AGENDA
PLANNING AND ZONING COMMISSION MEETING
CITY OF CREVE COEUR, MISSOURI
MONDAY, JUNE 15, 2020

**APPLICATION TO PLANNING AND ZONING COMMISSION
#20-002 & #20-010: BOUNDARY ADJUSTMENT, SITE DEVELOPMENT
PLAN AND CONDITIONAL USE PERMIT FOR QUIKTRIP GAS STATION
WITH CONVENIENCE STORE AT 11004, 11026, AND 11032 OLIVE
BOULEVARD AND 825 AND 827 GRAESER ROAD, AND THE
REDEVELOPMENT OF THE ADJACENT RETAIL CENTER
AT 11032 AND 11056 OLIVE BOULEVARD**

RE: Responses to Planning & Zoning Commission Comments & Questions
Proposed QuikTrip #613

WB-50 DELIVERY TRUCK MOVEMENT EXHIBIT

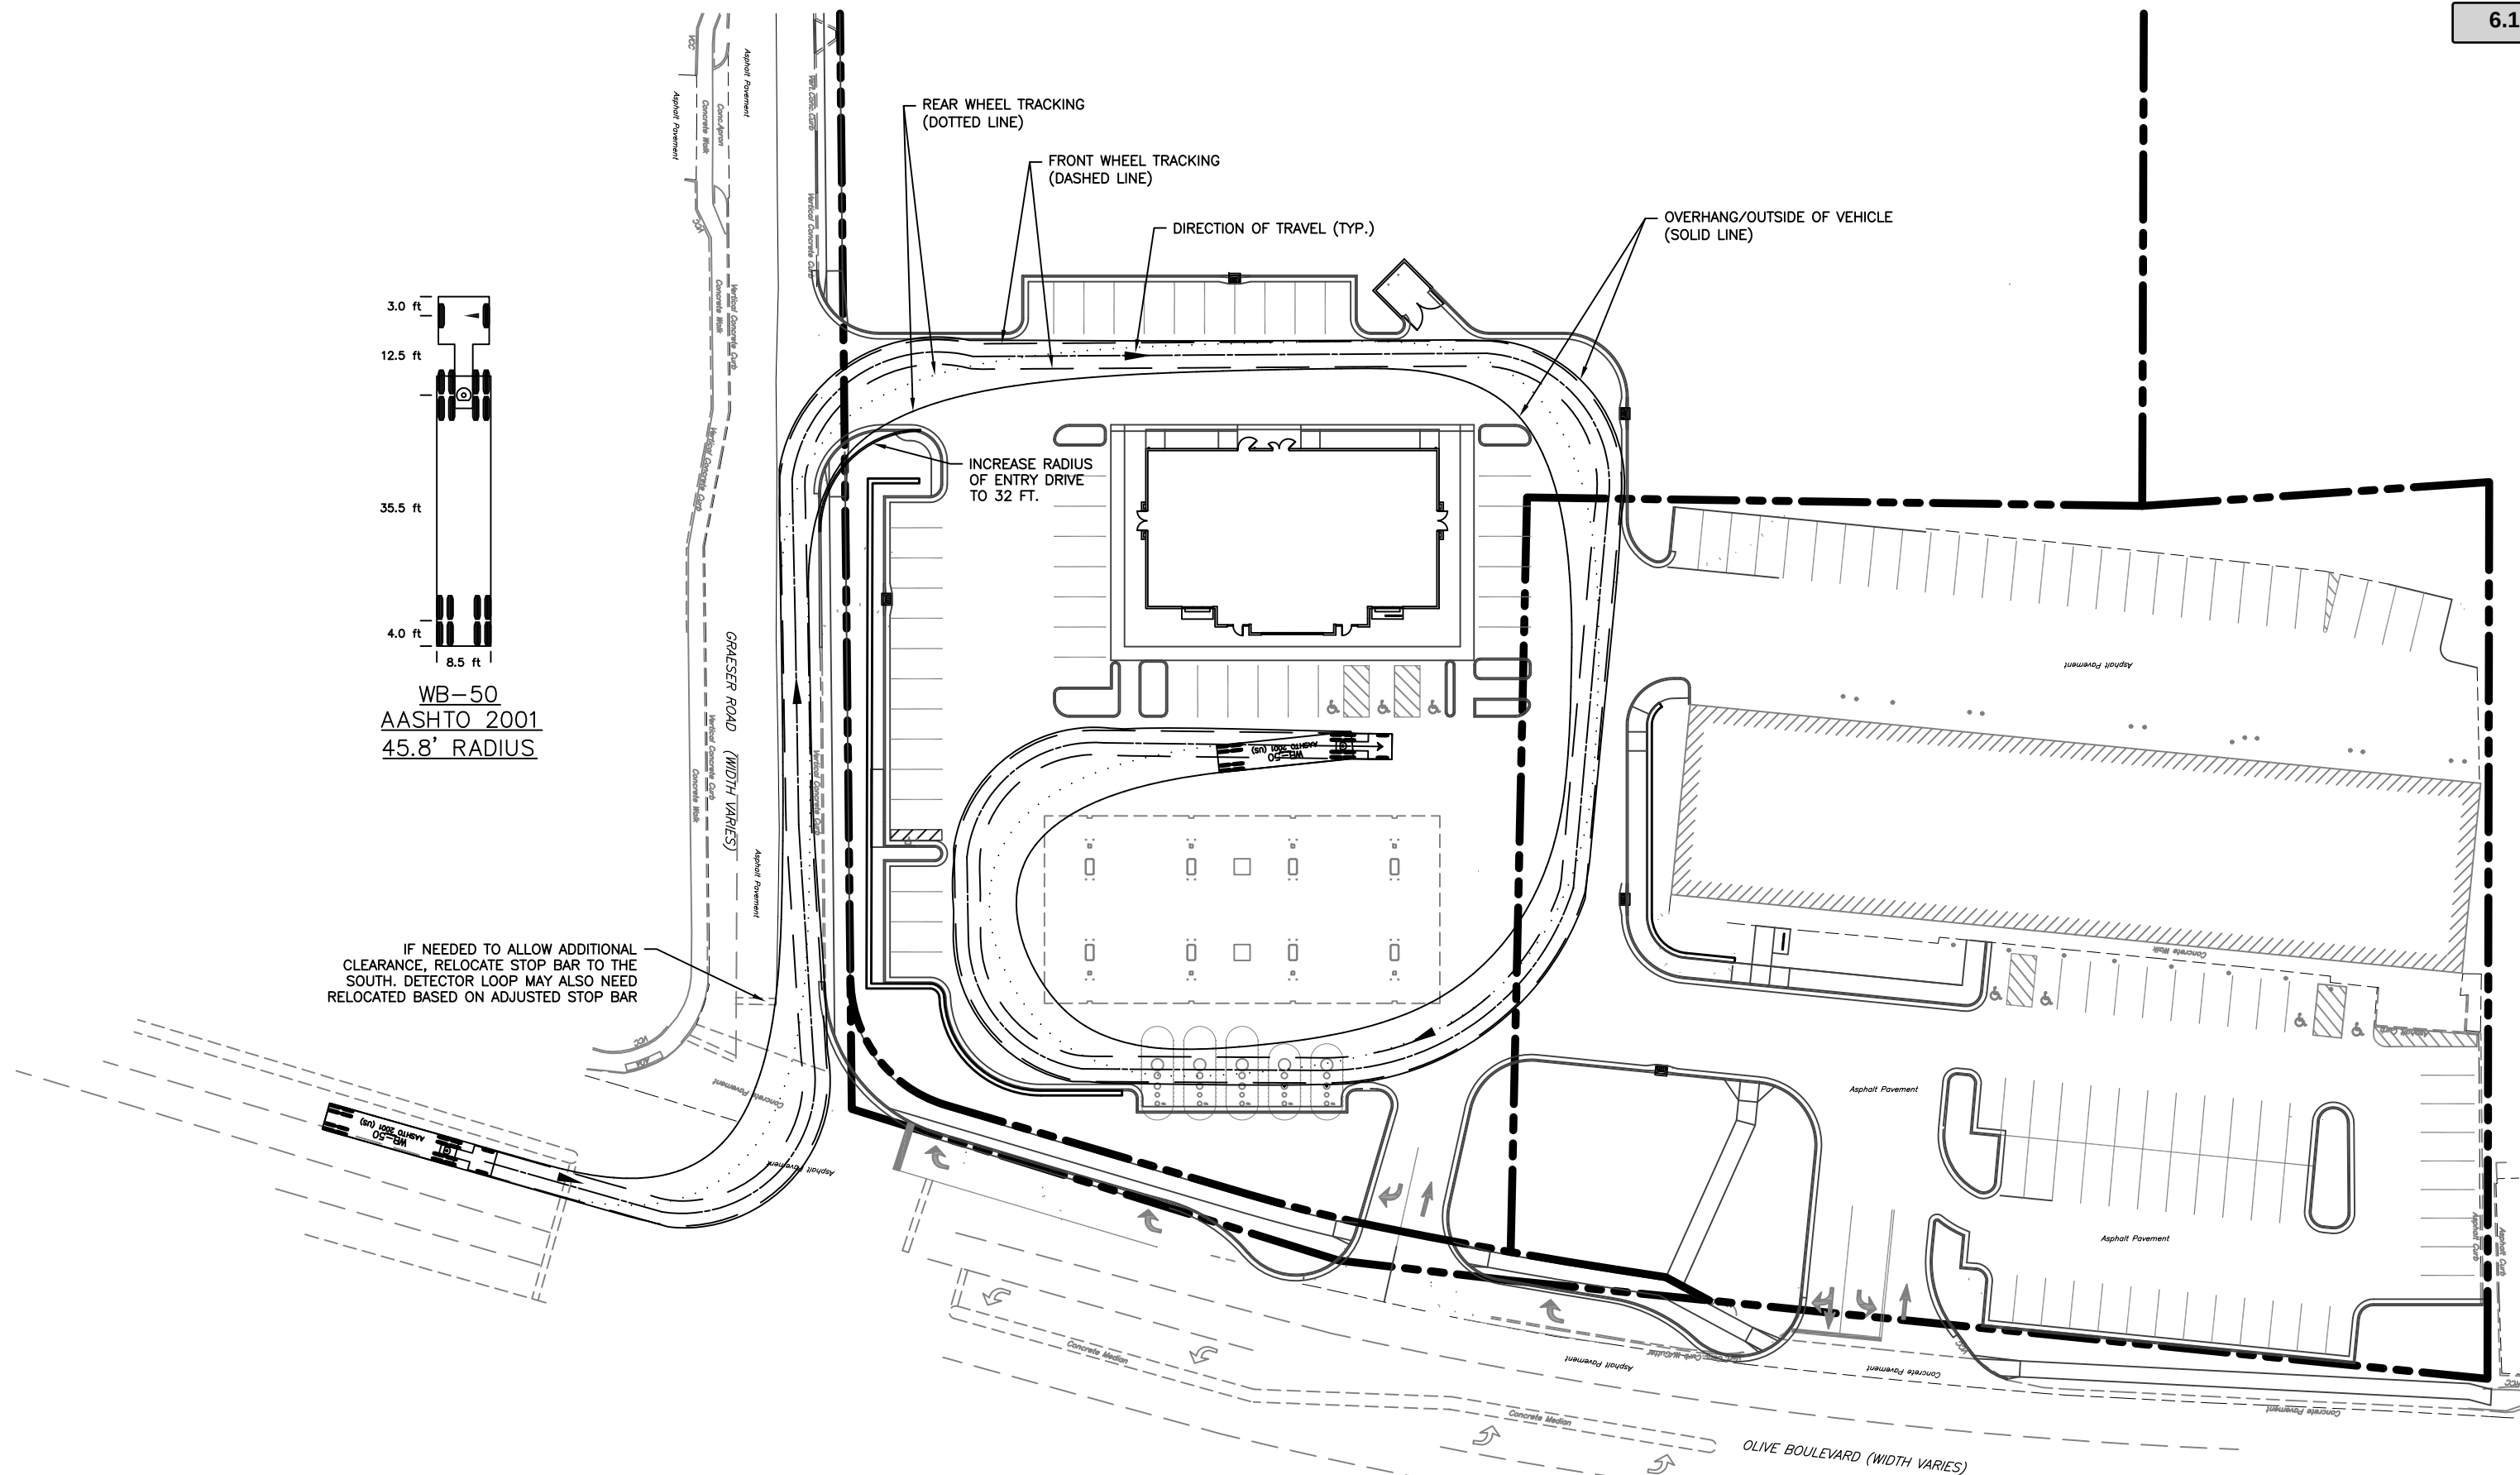
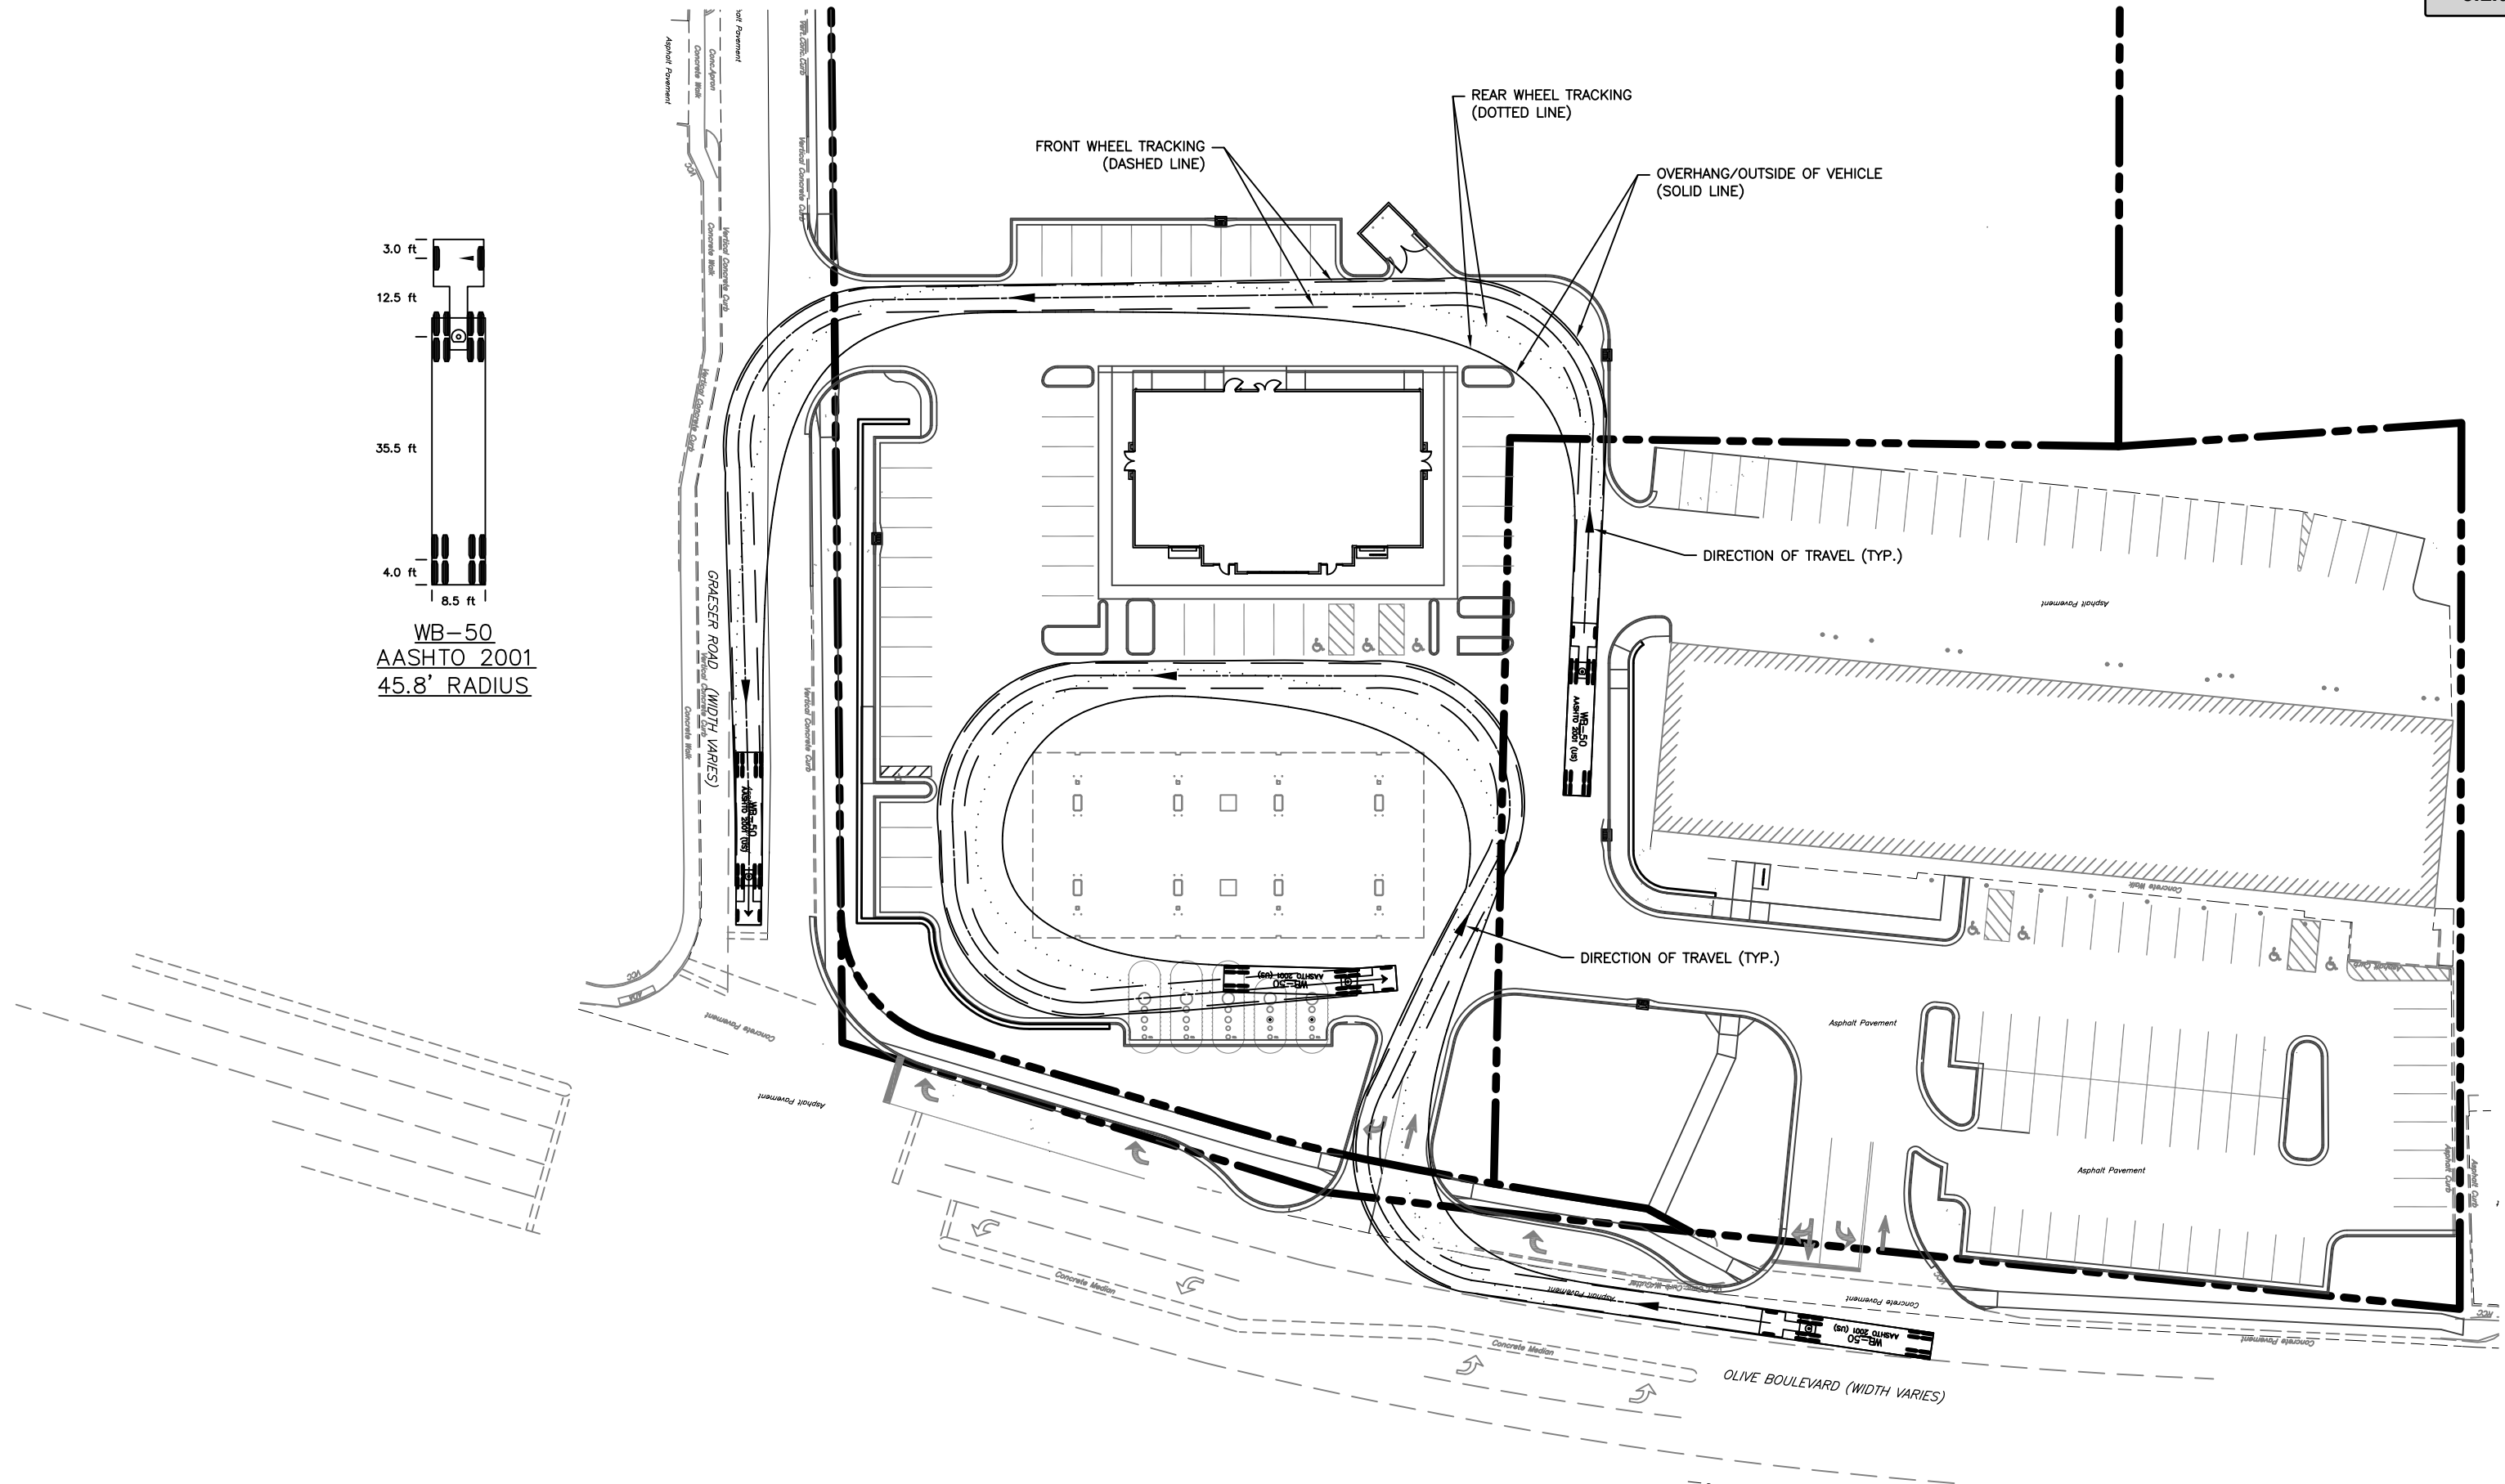
According to information provided by QT and CBB, they have adjusted the curb radius to better accommodate a turning truck. The Applicant has indicated a willingness to work with the City on scheduling the deliveries of the trucks to avoid rush hour/peak times. The Commission should discuss any further questions regarding deliveries with the Applicant.
